## CHANGE ORDER REQUEST

No. COR 059R-2

Project Name Tolleson Union High School No 7

Provide additional trenching and conduit to relocate existing Communications Utilities in the Right of Way along Avondale Blvd as required by regulatory agencies (CenturyLink) adjacent to the school's property.

**OVERALL CIVIL SITE PLAN**

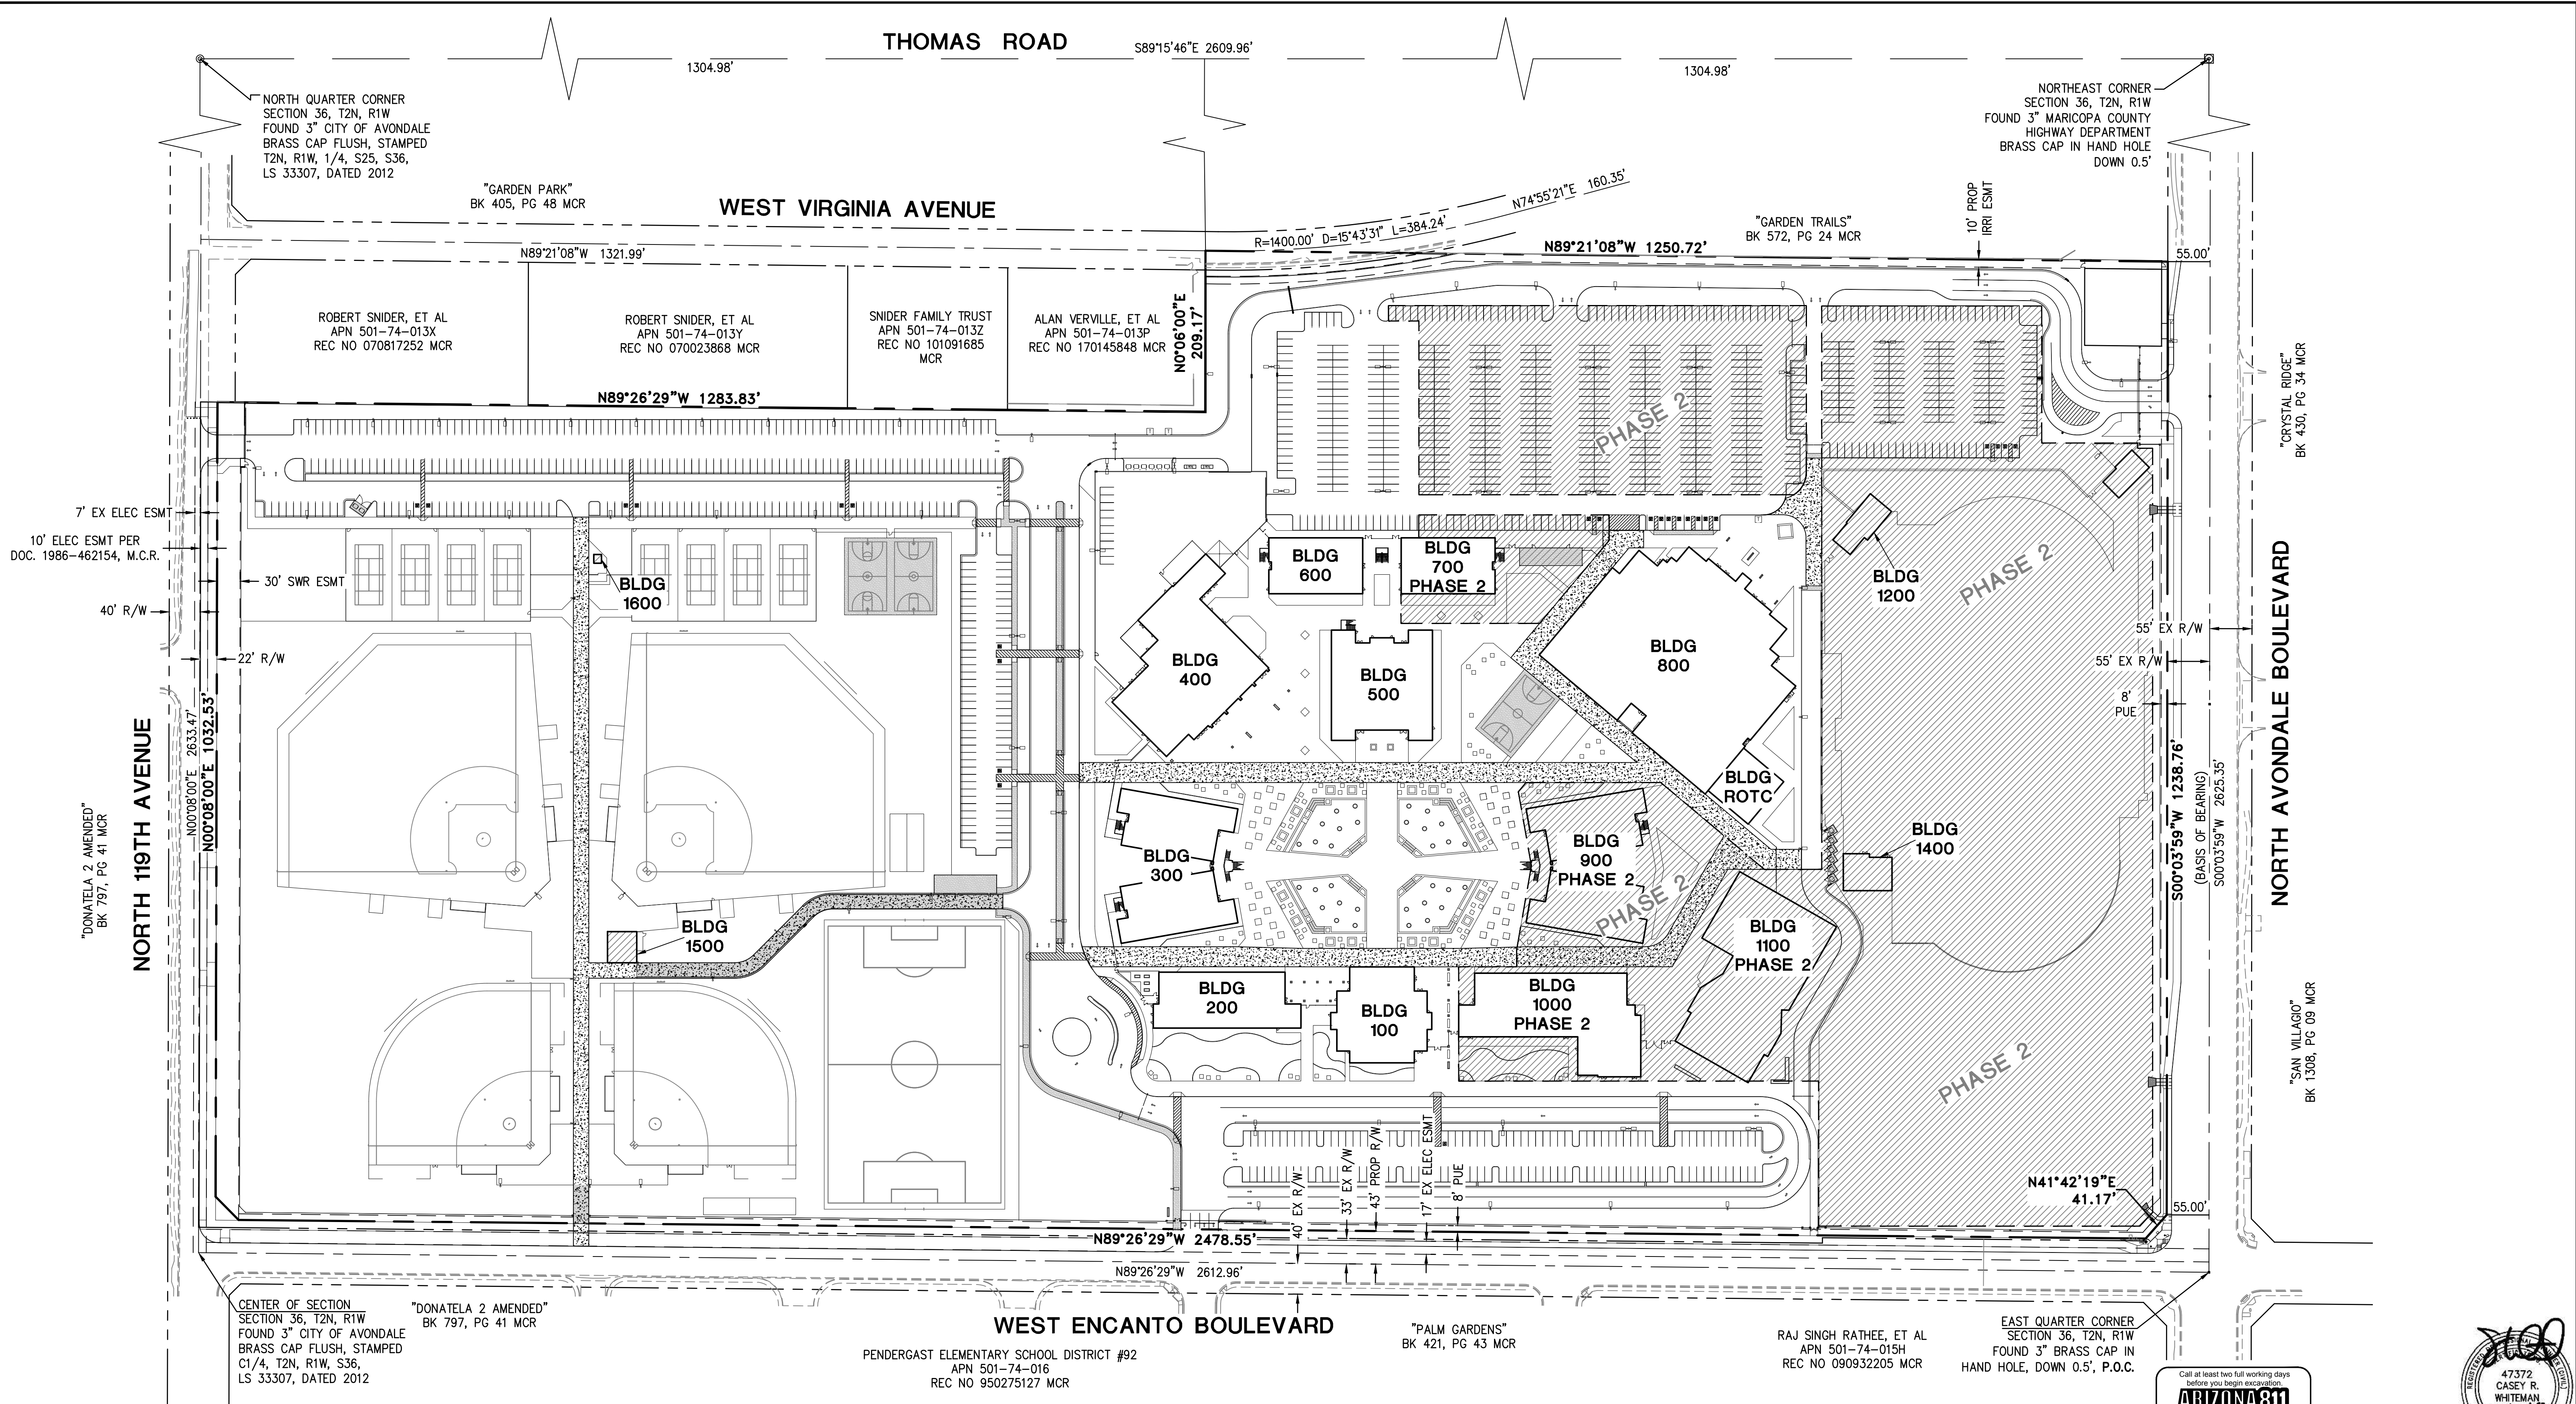
Place HH over  
existing Cables  
North of Conflict

## Dig Trench between Pit and HH.

# Dig Pit to expose cables South of Conflict

**Copper Solution:** In Trench at Pit location and near HH location the 600pr cable can be spliced and splice can be buried.

**Fiber Solution:** In Trench place Innerduct from pit to HH. At night, cut and pull fiber back to HH, then place new fiber through new Innerduct to the new HH. This will provide the necessary slack for splicing in the HH.
